REMARKS

III. Drawing Objections:

Fig. 2

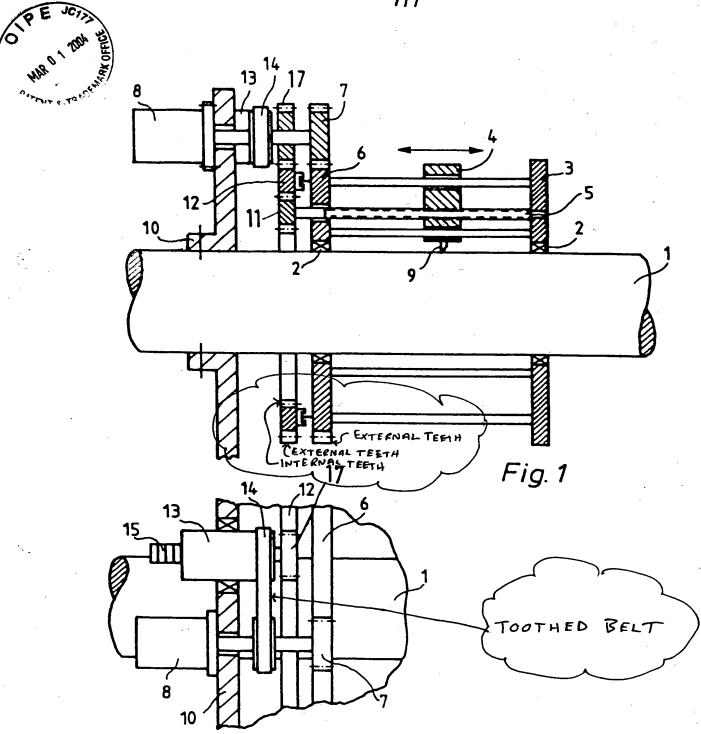
The Examiner objects to the drawings for the reasons noted at numbered paragraph 4 of the Office Action. Applicant does not believe that any changes to the drawings are necessary, but instead responds to the various drawing objections as follows, with reference to the marked up copy of Figs. 1 and 2 accompanying this Amendment.

An exemplary, non-limiting embodiment of the coupling between the main motor and the *housing* of the support motor is shown in Fig. 2 (which is a top view of Fig. 1). Here, as explained in paragraph [0022], the main motor 8 is coupled to the *housing* of the support motor 13 via the toothed belt 14. The toothed belt 14 is the coupling. See the marked up Fig. 2.

The Examiner also believes that the gear ring 12 is nested in the pinion 17. However, Figs. 1 and 2 clearly show that the pinion 17 is located on the radial outside of the gear ring 12.
